UNITED STATES PATENT AND TRADEMARK OFFICE

APPLICATION NO.	FILING DATE	FIRST NAMED INVENTOR	ATTORNEY DOCKET NO.	CONFIRMATION NO.
09/484,424	01/18/2000	Satoru Bushida	VX002067	9684

Office Action Summary

FIG.2

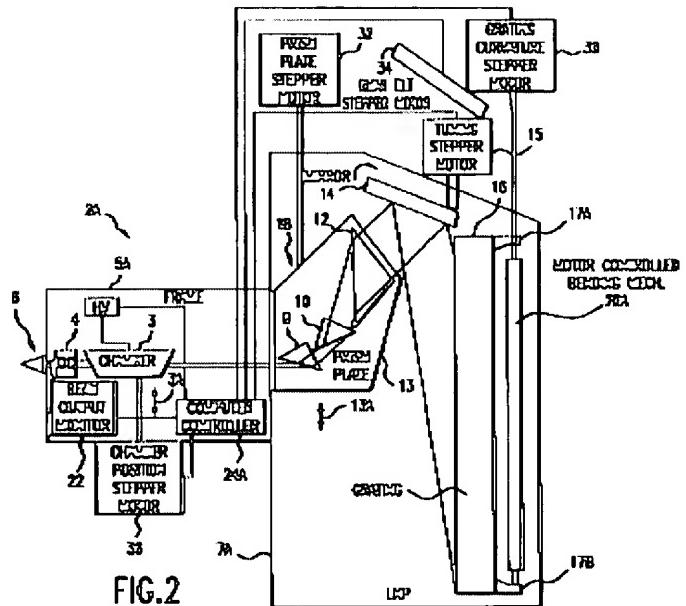
Claims 1 and 2 are rejected under 35 U.S.C. 102(e) as being anticipated by Erie et al.

Figure 2 illustrates a laser system having a grating (16) connected to a bending mechanism (20A) for providing compressive force or tension force for adjusting the curvature of the grating. The bending mechanism is connected to a grating curvature stepper motor for the controlling the grating curvature and holding the position of the grating constant, as disclosed in column 4 lines 38-45. As shown the bending mechanism and the stepper motor are separate structures where one provides the

curvature bending and the other controls curvature adjustment while maintaining it at a constant position.
